## PRODUCT/PROCESS CHANGE NOTICE (PCN)

PCN #: **TB0803-01**                      Date: **May 11, 2008**  
 Product Affected: **All products shipped in sealed moisture barrier bag.**  
 Date Effective: **August 11, 2008**

### ATTACHMENT I - PCN #: TB0803-01

**PCN Type:** Humidity Indicator Card

Fig.1: Photos of the Old and New HIC.

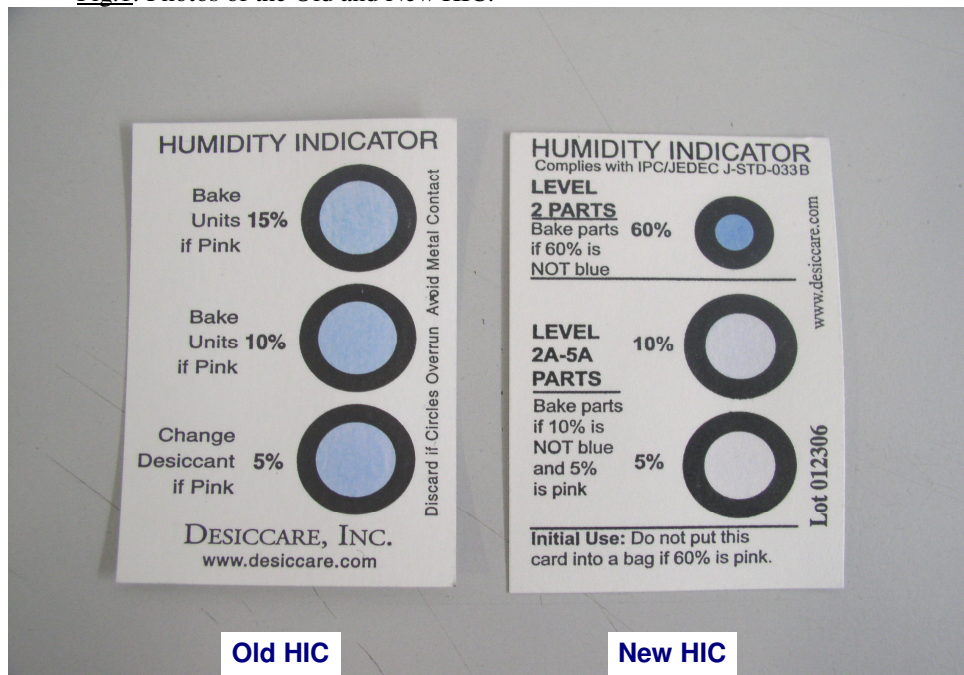
**Detail of Change:** This notification is to advise our customers that IDT will be changing the Humidity Indicator Card (HIC) to comply with the latest revision of JEDEC standard, J-STD-033B. This change will affect all products shipped in vacuum sealed moisture barrier bag.

Table 1 details the comparison between the Old and New HIC.

Description	Old HIC	New HIC
Supplier	Humipak, Malaysia	Humipak, Malaysia
IDT Part Number	SS-01-10053	SS-01-10125
%RH Indicator	5%, 10%, 15%	5%, 10%, 60%
Bake Condition *	i) 10% RH Indicator turns pink ii) 15% RH Indicator turns pink	i) Both 5% and 10% RH Indicators turn pink ii) 60% indicator turns pink
